PLANNING AMENDMENTS

Project
TWICKENHAM STADIUM EAST STAND EXTENSION

DETAILED ELEVATION

Doc ref	Project number	Drawing number	Revision
100-KSS-DR	15735	303	P03

1 ELEVATION
 DETAILED GA ELEVATION
 1 : 100

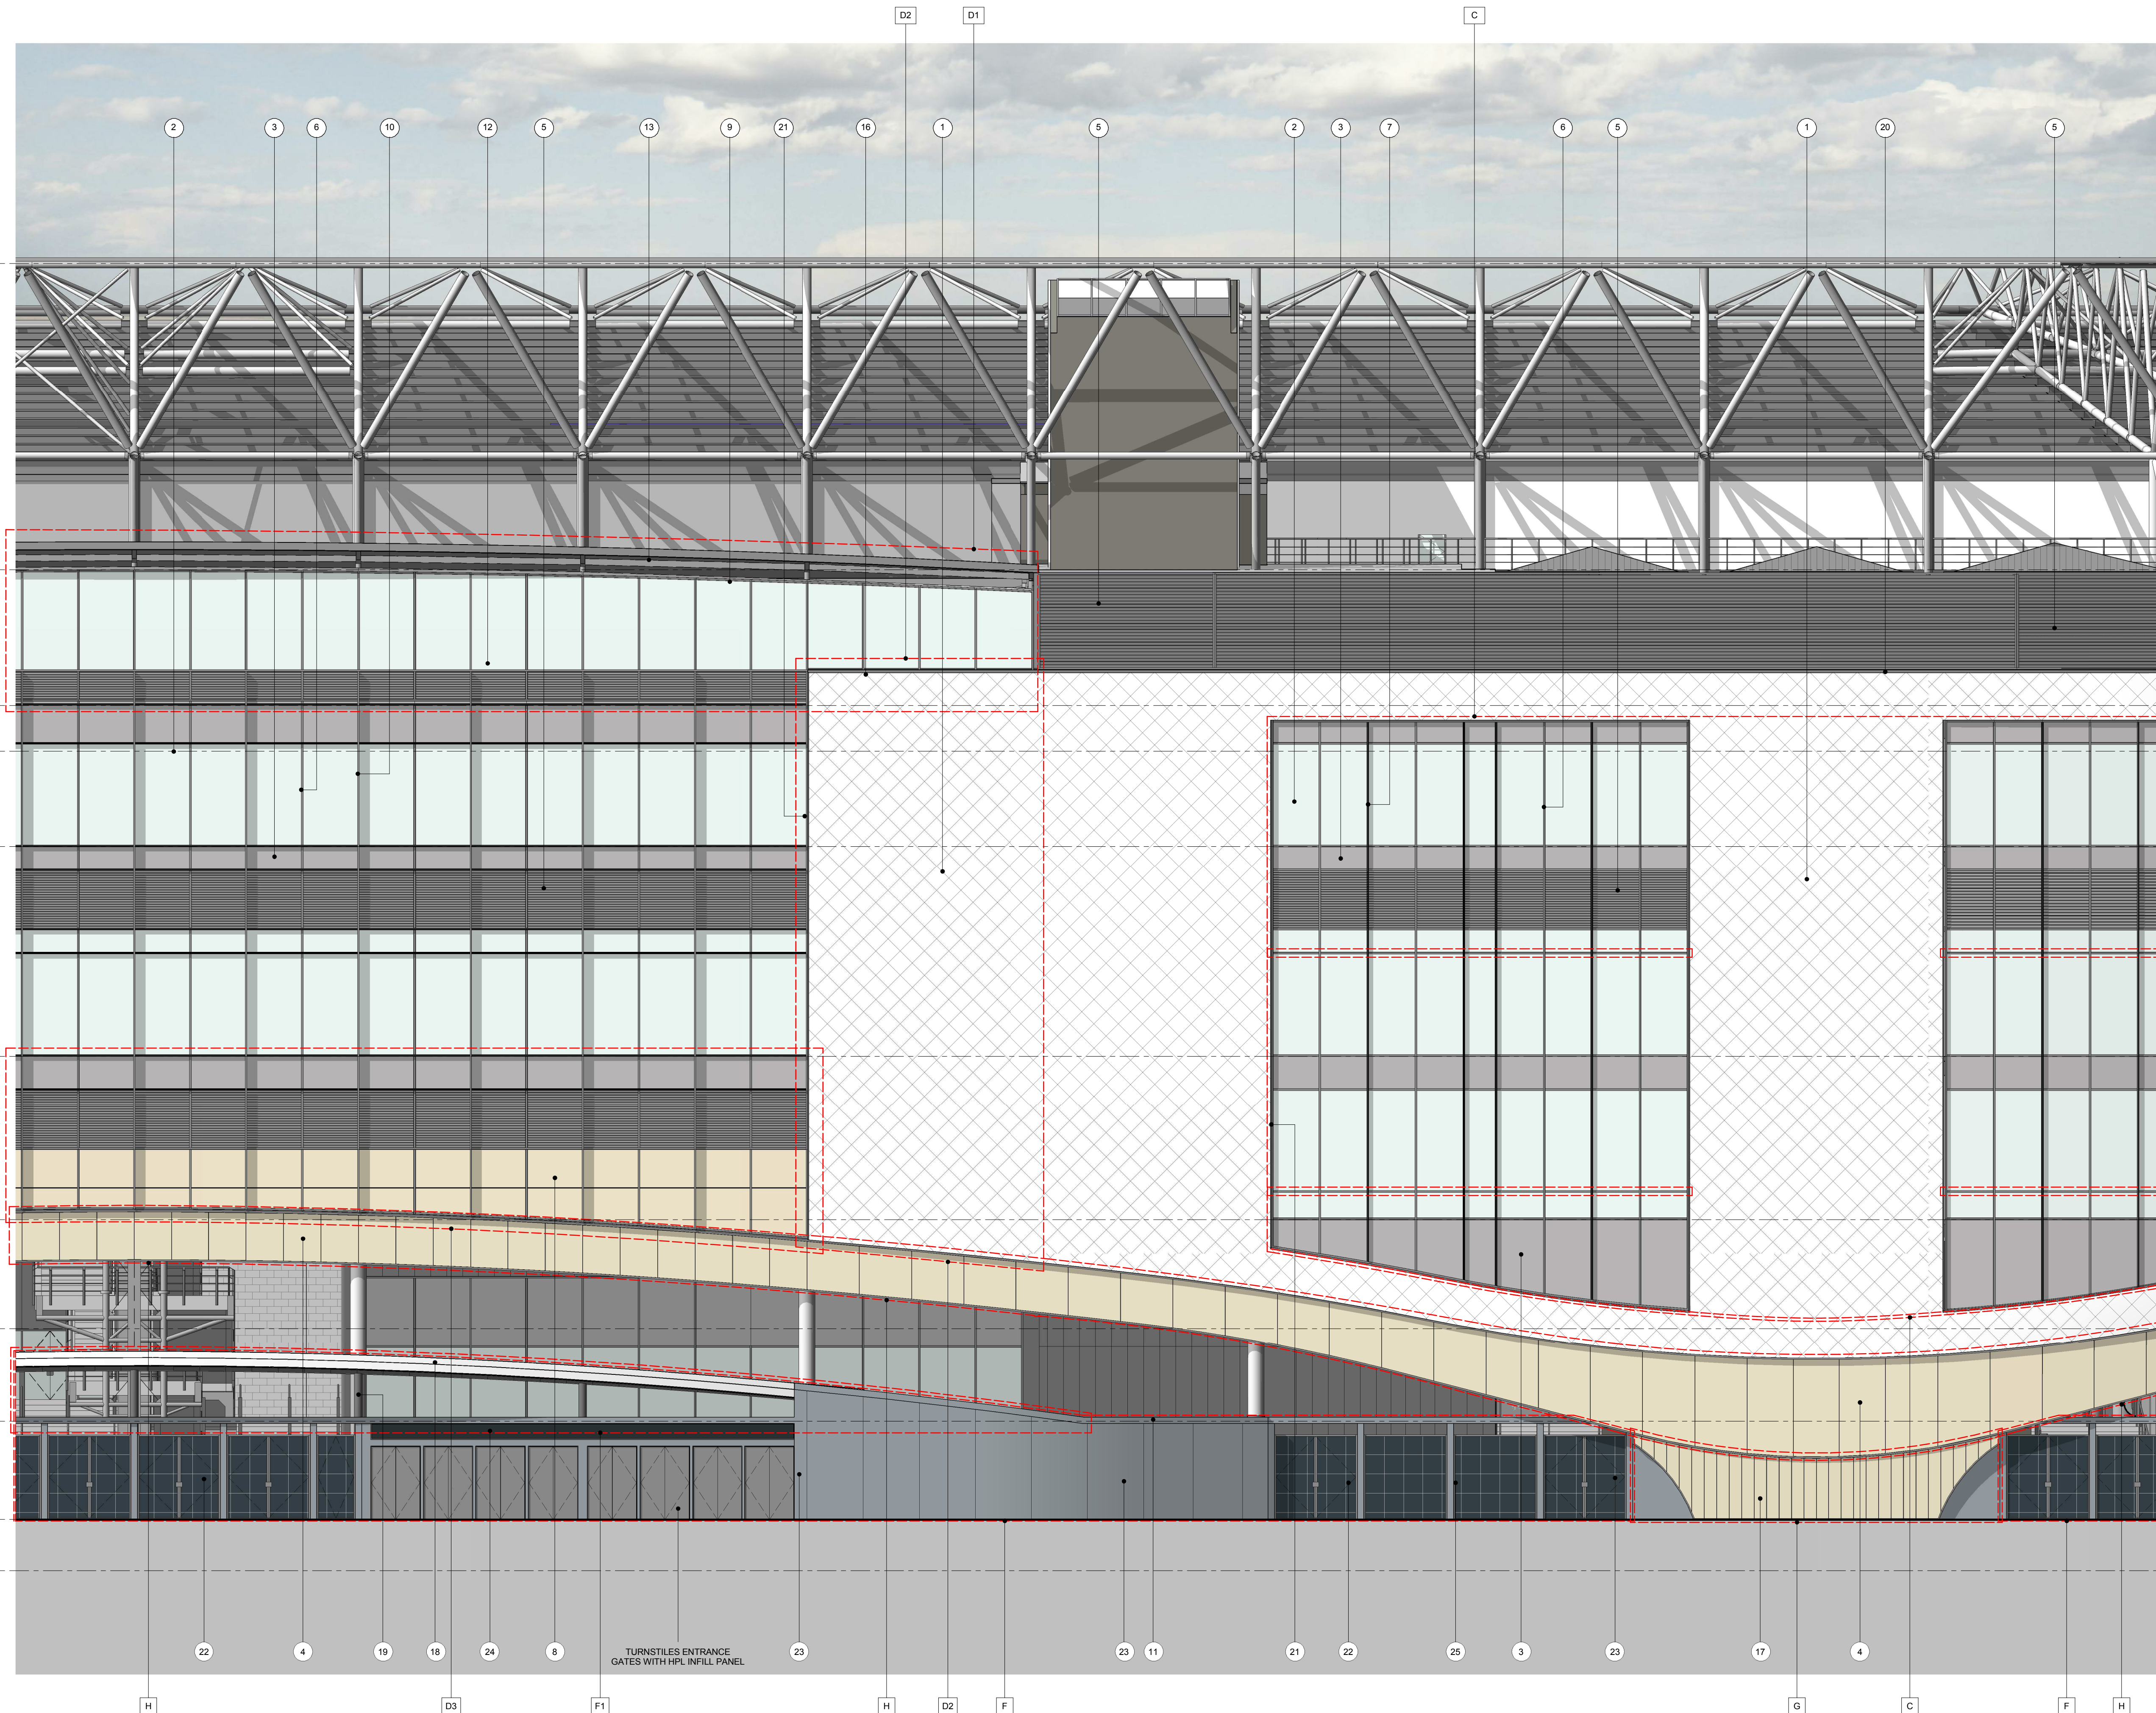
- A GENERAL AMENDMENTS TO THE SOUTH END.
- A1 INCREASED SHINGLES CLADDING AREA AND CURTAIN WALL REDUCED ACCORDINGLY.
- A2 REDUCED MASSING AND REVISED INTERFACE WITH THE SOUTH STAND.

- B PPC LOUVRES LOCATED TO THE BOWL SIDE HAVE BEEN OMITTED.
- C CURTAIN WALL SETTING OUT REVISED GENERALLY. SILICONE JOINTS TO TRANSOMS AND MULLION REPLACED WITH CAPPED SYSTEM. LEVEL 04 PPC LOUVRES SETTING OUT & HEIGHT REVISED. MONORAIL FOR ABSEILING REMOVED.

- D GENERAL AMENDMENTS TO THE CENTRAL ELEVATION CANOPY AT LEVEL 5A REVISED GENERALLY AND STANDING SEAM REPLACED WITH SINGLE PLY MEMBRANE. SUPPORT COLUMNS TO ROOF CANOPY REVISED. SQUARE FASCIA TO ROOF EDGE.

- D1 LEVEL 5A GLAZED SCREEN EXTENDED IN HEIGHT AND PPC LOUVRES INCLUDED AT LOW LEVEL.
- D2 INCREASED SHINGLES CLADDING AREA AND CURTAIN WALL AREA REDUCED ACCORDINGLY. FOUR VERTICAL FINN REMOVED.

- D3 PORCELAIN PANELS WITH SLOTTED HOLES FOR VENTILATION REPLACED WITH PPC LOUVRES. EXPRESSED HORIZONTAL PATTERN TO PORCELAIN PANELS OMITTED.
- E GENERAL AMENDMENTS TO THE NORTH END

- E1 PORCELAIN CLADDING REPLACED WITH PPC ALUMINIUM CLADDING.
- E2 GREEN WALL TO THE NORTH END EXTENDED AND PPC LOUVRES REMOVED.
- E3 INCREASED SHINGLES CLADDING AREA AND CURTAIN WALL REDUCED ACCORDINGLY.

- F FENCING, GATE AND PERIMETER COLUMNS SETTING OUT REVISED.
- F1 CANOPY TO TURNSTILES REVISED.
- G PORCELAIN PATTERN CHANGED FROM HORIZONTAL TO VERTICAL.

- H PORCELAIN PANELS TO THE SOFFIT OF THE ARCH REPLACED WITH PPC ALUMINIUM PANELS. PORCELAIN PANELS SETTING OUT REVISED.
- K ROOF TO LEVEL 5A (NORTH END) EXTENDED.

- L GLAZED SPANDREL PANELS REPLACED WITH METAL SPANDREL PANEL. PORCELAIN PANELS REPLACED WITH PPC ALUMINIUM CLADDING.
- L1 PPC LOUVRES INCLUDED FOR MECHANICAL VENTILATION.
